DRAINAGE AND TRANSPORTATION INFORMATION SHEET

Project Title: Blvd 2500 **Building Permit #** _____ **Hydrology File #** _____

DRB# PR-2018-00158 **EPC#** _____

BLVD 2500 ALBUQUERQUE, NM	DRAWN BY SB
	TRAFFIC CIRCULATION LAYOUT	DATE 01-16-23
	TIERRA WEST, LLC 5571 MIDWAY PARK PL NE ALBUQUERQUE, NEW MEXICO 87109 (505) 858-3100 www.tierrawestllc.com	DRAWING
		SHEET # TCL-1
RONALD R. BOHANNAN P.E. #7868		JOB # 2022083

C1.0

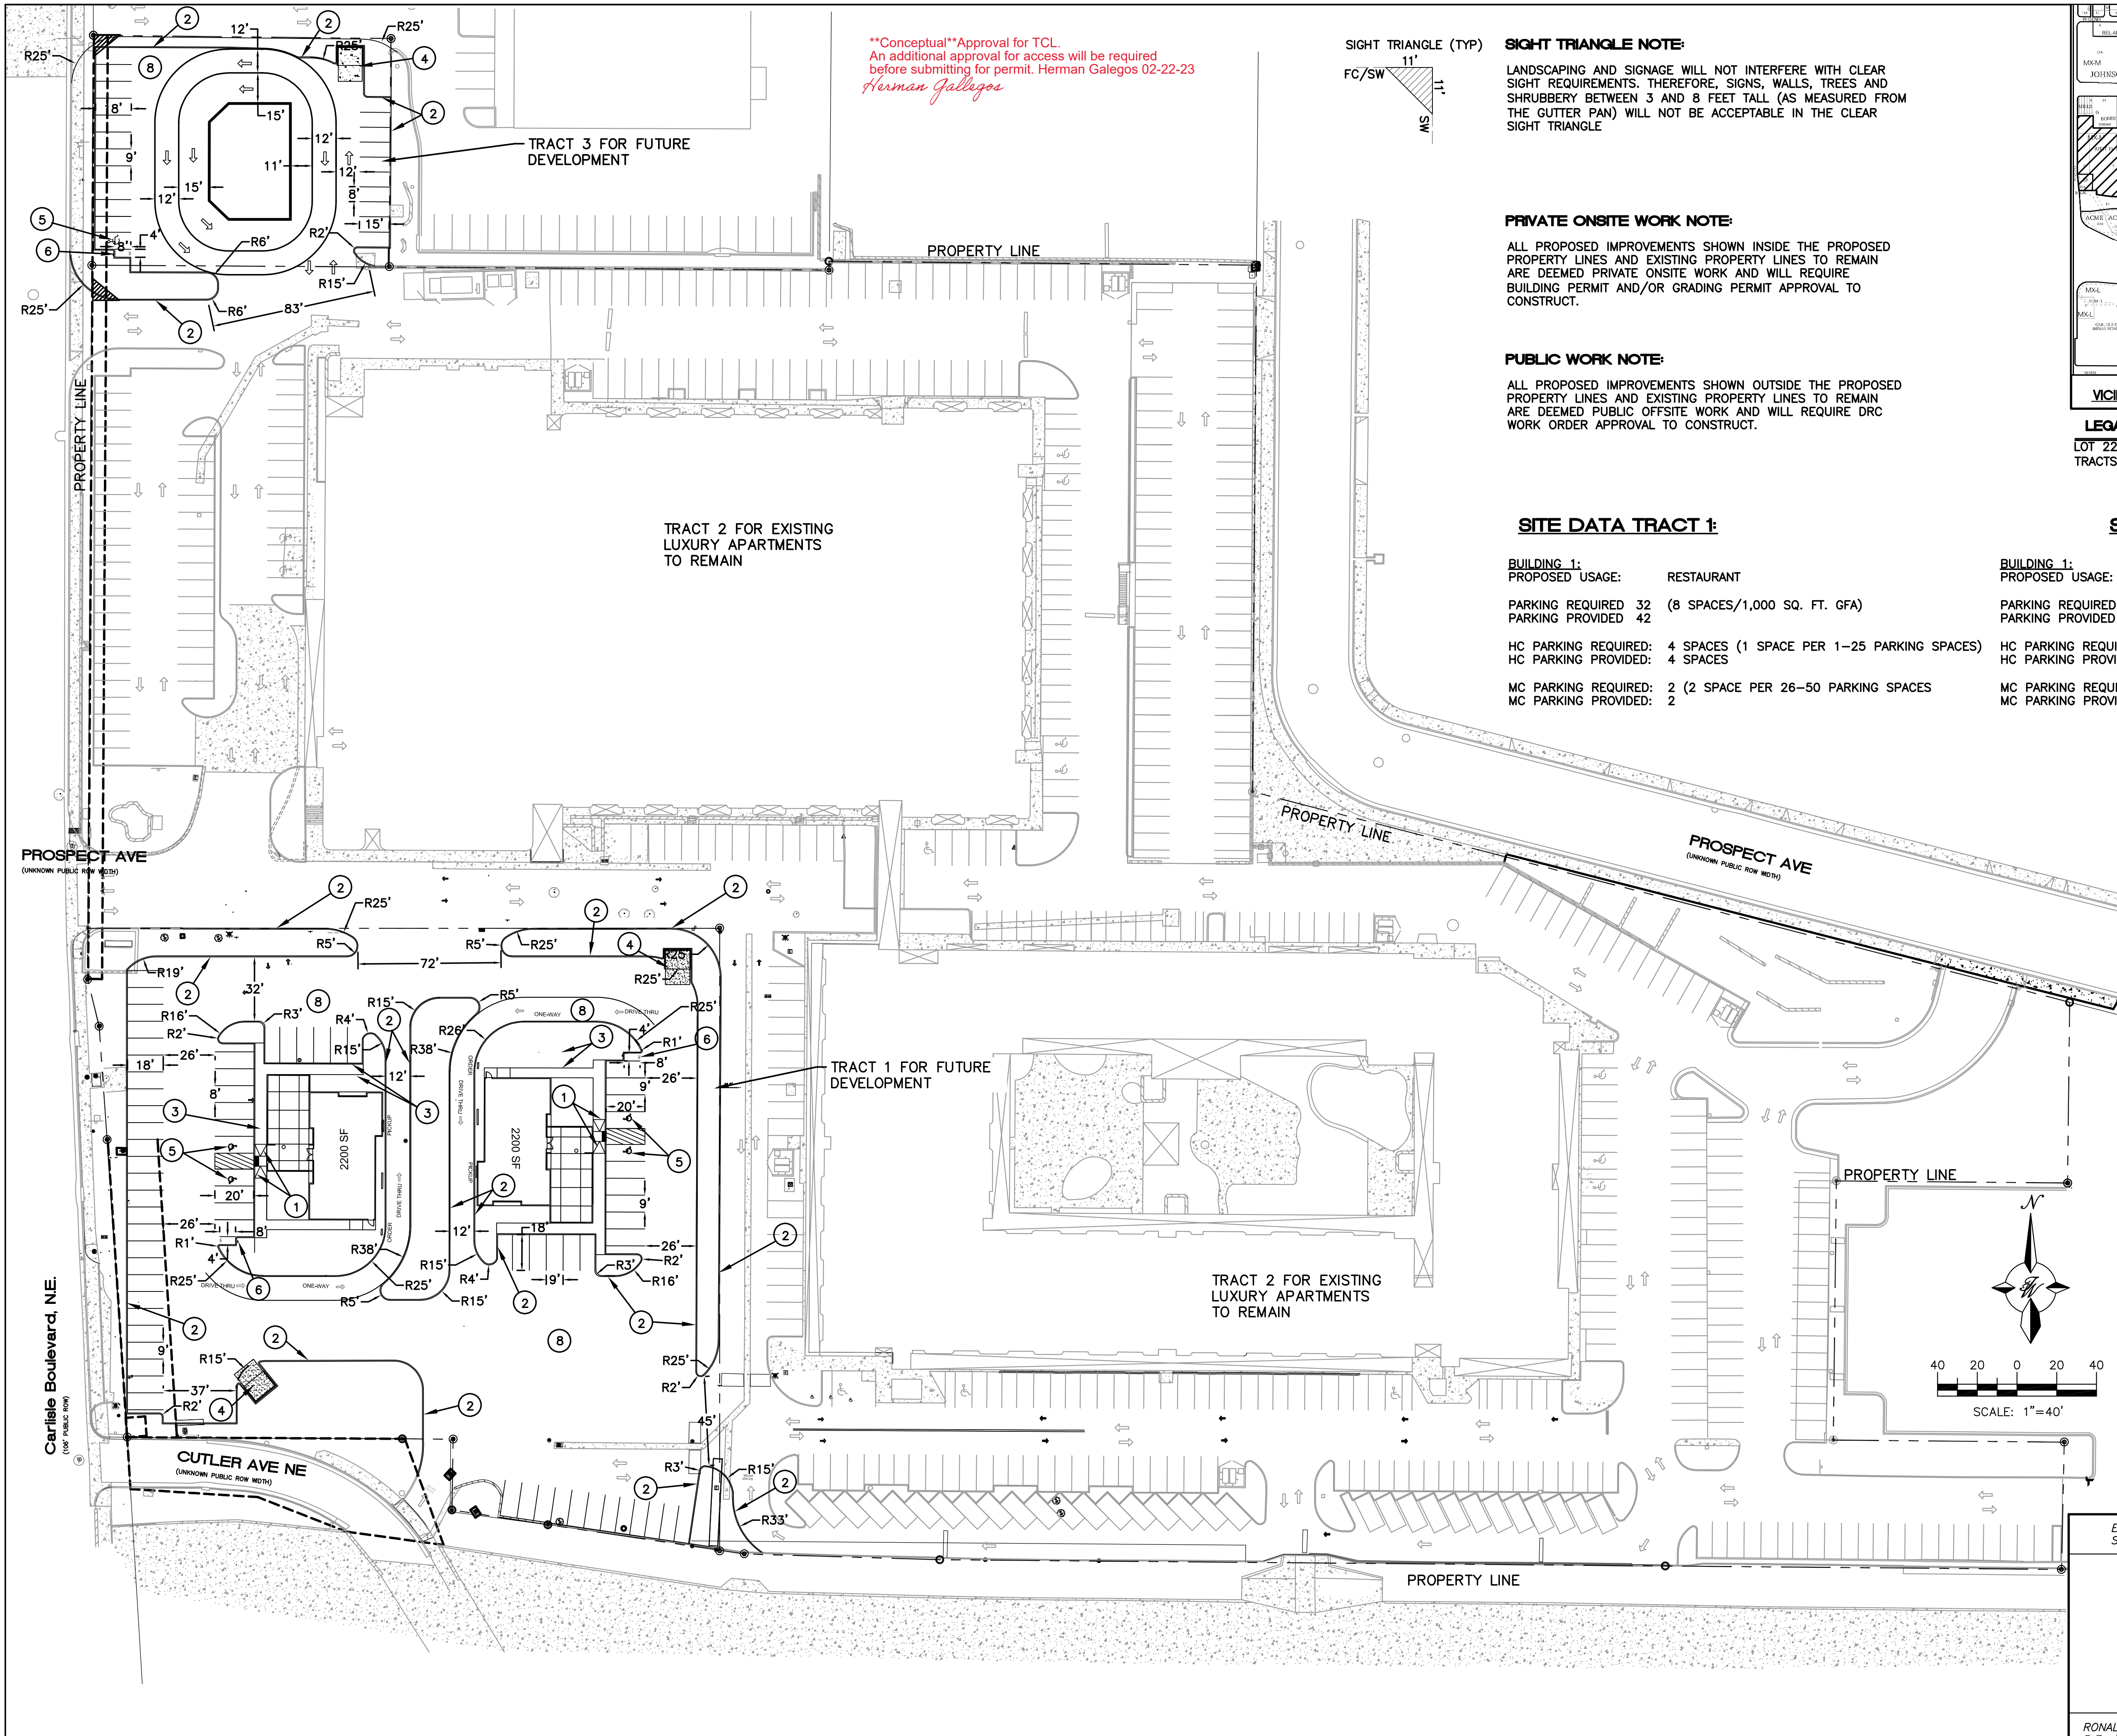
****Conceptual**Approval for TCL.**
An additional approval for access will be required before submitting for permit. Herman Galegos 02-22-23
Herman Galegos
